XEROX EOD	Project D0	Maintenance Panel	File D0mp01.sil	Designer Rosen	Rev Gc	Date 6/11/79	Page 01
--------------	---------------	-------------------	--------------------	-------------------	-----------	-----------------	------------

XEROX EOD	<i>Project</i> D0	Maintainance Panel Changes	<i>File</i> D0MPchanges.sil	<i>Designer</i> Rosen	<i>Rev</i> Gc	<i>Date</i> 6/11/79	<i>Page</i> 01
---------------------	----------------------	-----------------------------------	--------------------------------	--------------------------	------------------	------------------------	-------------------

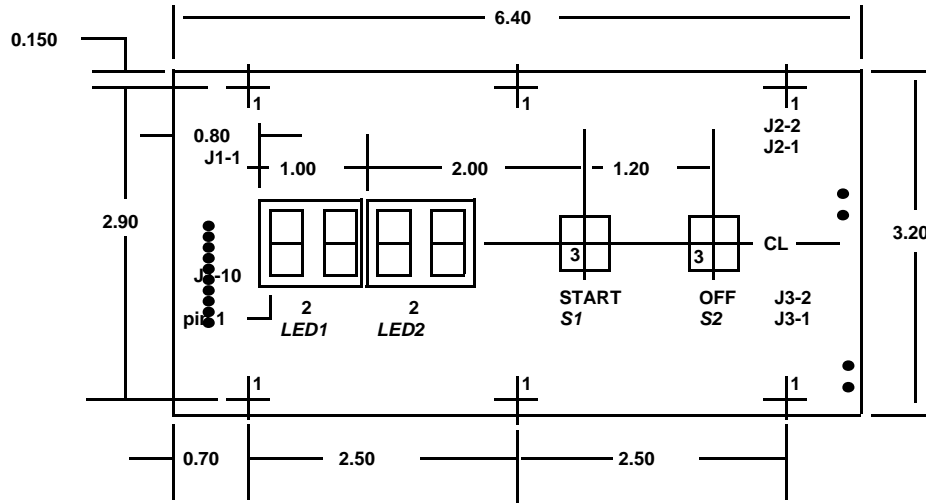
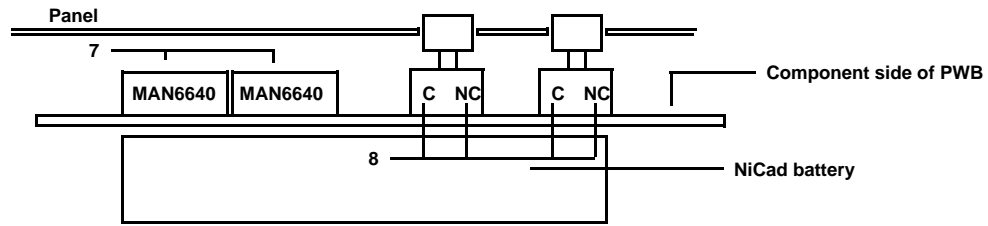
Changes for revision Ga to Gb (4-27-79 CT)

- 1) Changed IC2 from S38 to N38
- 2) Changed C8 from 100 pf to 200pf
- 3) Changed R2 from 470 ohms to 47 ohms (initial loading chart was incorrect).
- 4) Removed components C13, C14, and R39

Changes for revision Gb to Gc (6-11-79 CT)

- 1) Added .01uf cap and 1k resistor in series with PnlBoot. This is the line that boots the machine; this change causes the boot signal to be a negative-going pulse at the end of the ~700ms time delay that starts when the boot button is released.
- 2) Added NPN emitter follower to signal TimeOut to assist the feeble CMOS output of the TMS1000C.
